Analyses in Support of Z-Pinch IFE and Actinide Transmutation - LLNL Progress Report for FY-06

W. R. Meier, R. W. Moir

September 20, 2006

As part of our work for SNL in FY06, we were asked to review the In-Zinerator design and provide feedback. This note documents some of the issues that were identified and suggests design improvements to address them. This note also includes several calculations related to the response of the chamber to fusion and fission energy pulses. Some of these calculations are based on scaling from calculations carried out for previous IFE chamber designs. As such they should be considered as rough estimates and verified with more detailed analyses for the In-Zinerator chamber. The following topics are discussed in this section:

Figure 6.1: Present In-Zinerator design.

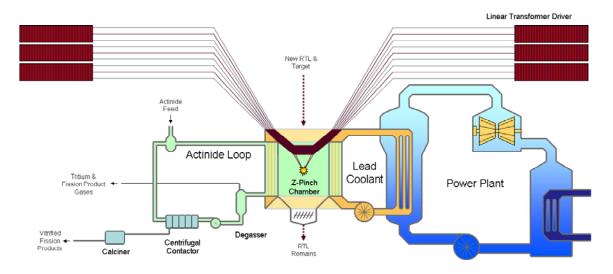
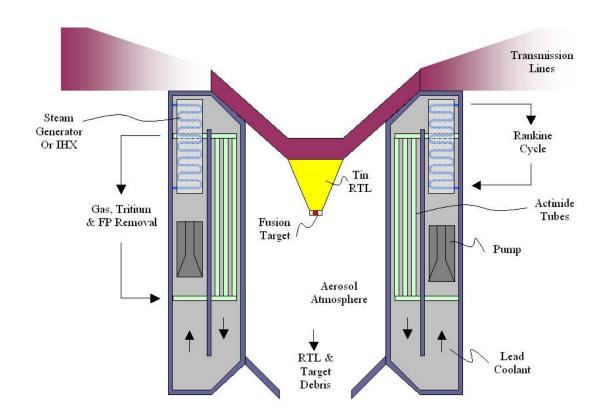
- The bare first wall will erode by ablation and suffer shock damage unless it is protected. This
 is a critical issue and must be resolved. The proposed use of a buffer gas may be adequate to
 reduce the peak heat load, but the potentially high debris fraction makes this approach
 difficult.
- 2) Without coverage at the top and bottom of the chamber, 20% of the source neutrons are lost and scattered neutron loss is increased as well. This is a lot of coverage area and performance to give up. It is not necessarily a feasibility issue, but will impact attractiveness in terms of overall transmutation rate and tritium breeding.
- 3) The first wall is much thicker (5 cm) than previous IFE chamber designs and will result in loss of available neutrons for transmutation and tritium breeding.

Figure 6.3: Modifications to present design.

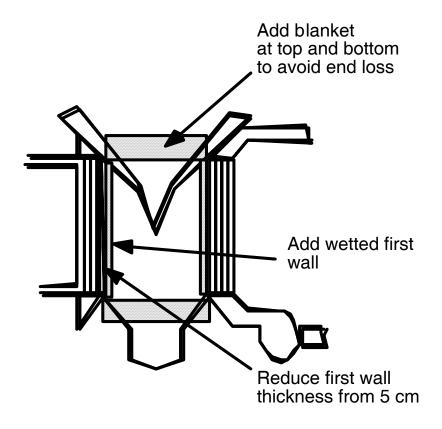
In Fig. 6.3 we show schematically how top and bottom blankets can be added to improve the neutron economy. A wetted first wall of flowing liquid is added to protect against ablation. Finally we suggest using a thinner (< 5 cm) first wall if possible. (See stress calculations that follow.)

It is easy to add the liquid wetted wall with lots of examples, for example the recent KOYO design.² A bottom blanket with provisions for venting and passage of RTL debris can also be added. Over 99% of the power is deposited in the flowing molten salt. An external heat exchanger would be less demanding than a heat exchanger to the lead coolant located inside the neutron flux region. These changes, i.e., adding top and bottom blankets and removing the heat exchanger from the blanket, are shown schematically in Fig. 6.4.

Fig. 6.4: Further modifications.

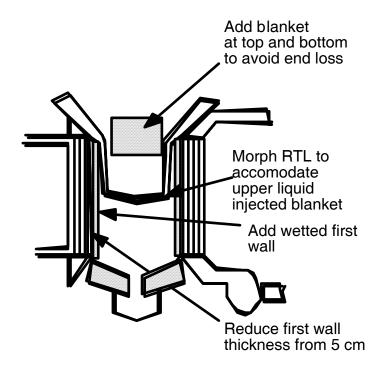
It is unclear how to add a blanket on top without interfering with the RTL except by the method suggested by LLNL for Z-IFE chamber. Our design for Z-IFE shown in Fig. 6.5 is a starting point for the morphed RTL. The flibe jets surrounding the target would be replaced by the tubular design of the In-Zinerator.
